# TECHNICAL SERVICE BULLETIN

**REF.:** AUDIO  
**NO.:** AU92-004  
**DATE:** AUGUST 21, 1992  
**MODEL:** ALL MODELS

## CD INOPERATIVE ON '92 PANASONIC 3-IN-1 RADIOS (56804 & 56801)

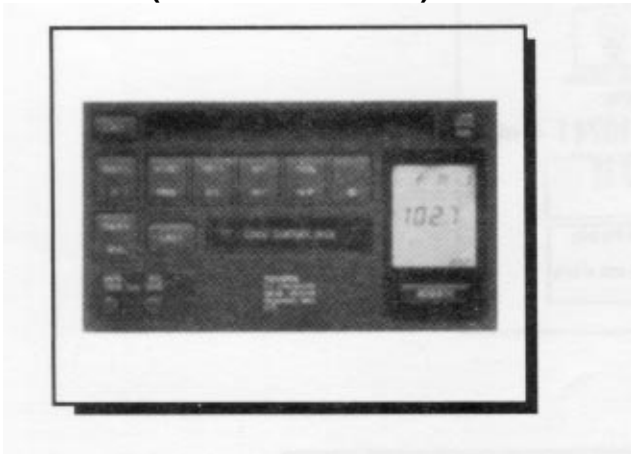
CD won't play or CD skipping conditions may occur on 3-in-1 radios 56804 (P/N 86120-33100) and 56801 (P/N 86120-2A022). This can be caused by the following:

- 1) Optical lens of the CD changer deforms with high temperature.
- 2) Guide pins contact the CD during play.

Production change has been made by Panasonic to the CD player's optical pick-up and guide pins starting 12/91 (vehicle production date).
